Observation Report

Date:	December 16, 2016	Observation Date:	December 9, 2016
Architect:	Cannon Design	Location:	Webster ISB - General
Attn:	Kelvin Patel	Observer:	Patrick Garner
Gen. Contr.:	Paric	M/E/P/F Contr.:	Varies
File:	Webster University Interdisciplinary Science Bldg. WT 14127.01 (7)	c:

Mechanical

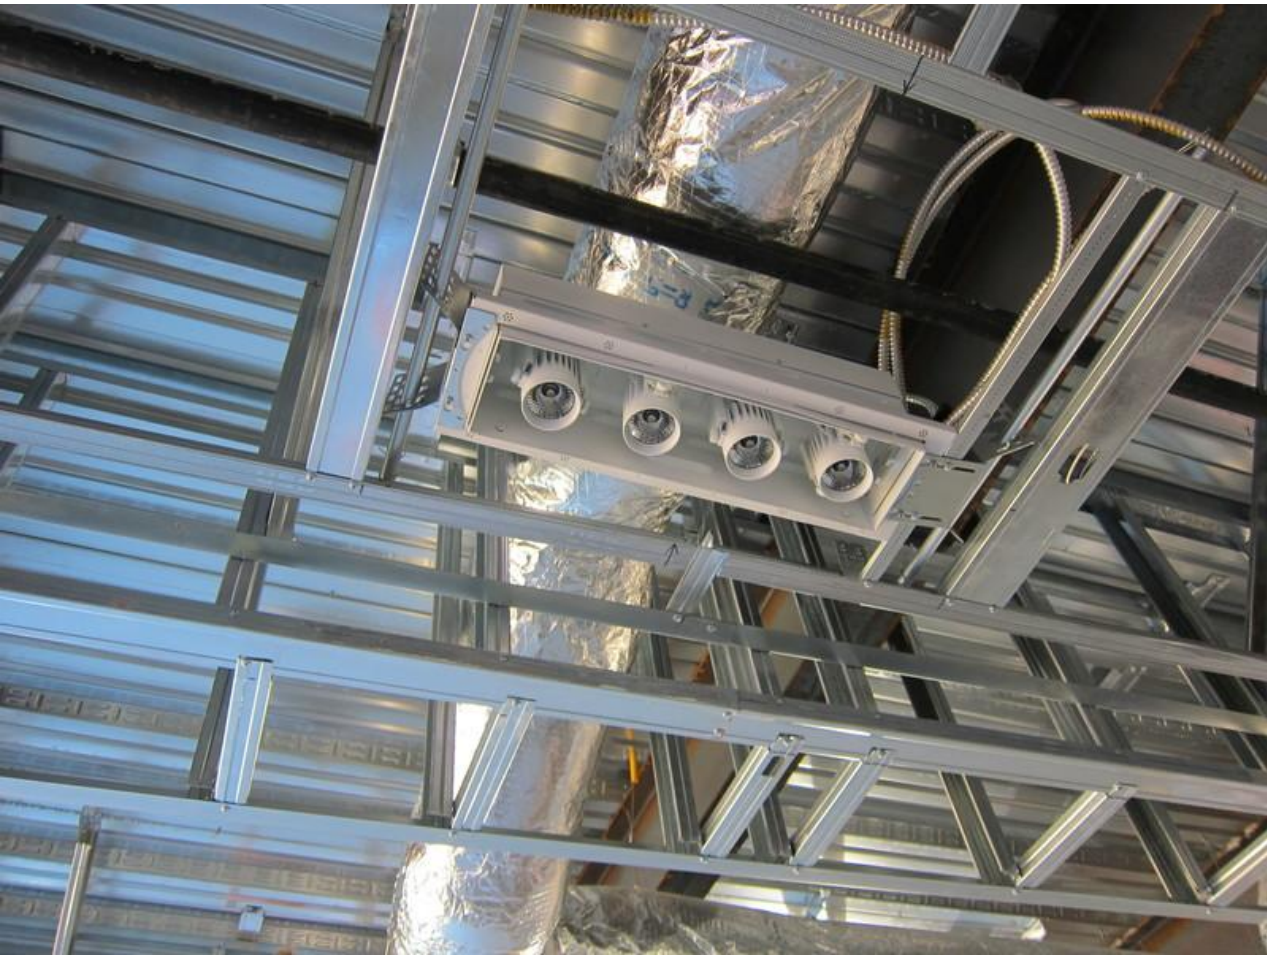
Issue ID	Description	Location Detail	Location	Status	Company	Type	Date Created	Due Date
000312	Lighting is being installed in the Lecture Hall. It seems pretty early to install these lights. We are concerned about the high level of dust affecting the fixtures. Please consider temporary protection or consider delaying the lighting install until construction is further along.		Webster > LEVEL_01	Open	Guarantee Electric	11 Month Warranty Walk	13 Mar 2017	18 Mar 2017

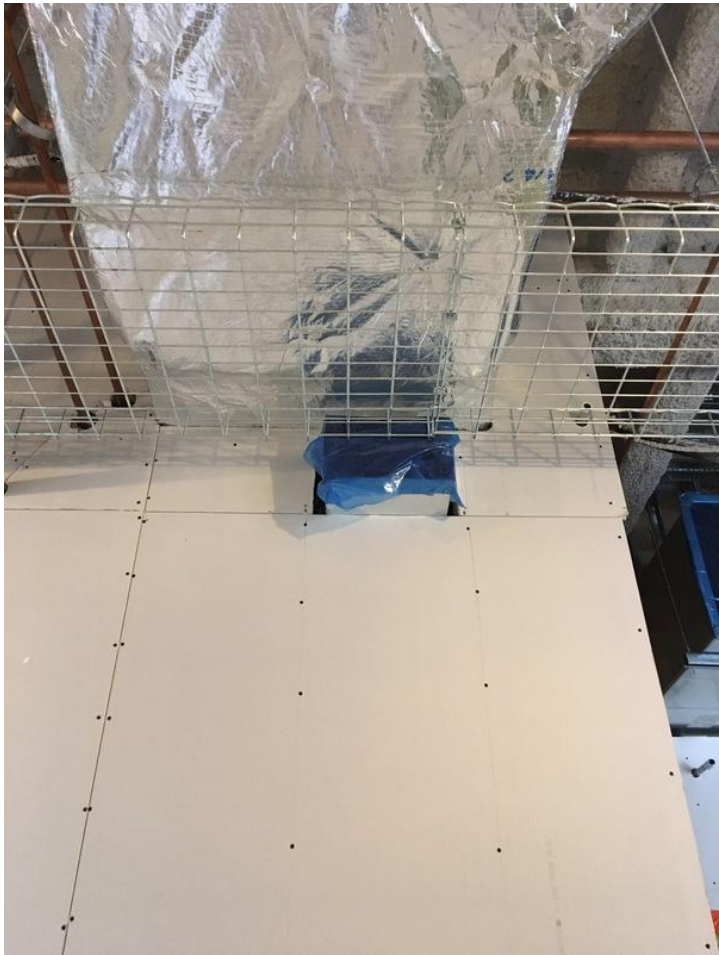
Issue ID	Description	Location Detail	Location	Status	Company	Type	Date Created	Due Date
000308	Coordinate duct and cable tray.		Webster > LEVEL_02	Open	ICON Mechanical	11 Month Warranty Walk	10 Mar 2017	15 Mar 2017
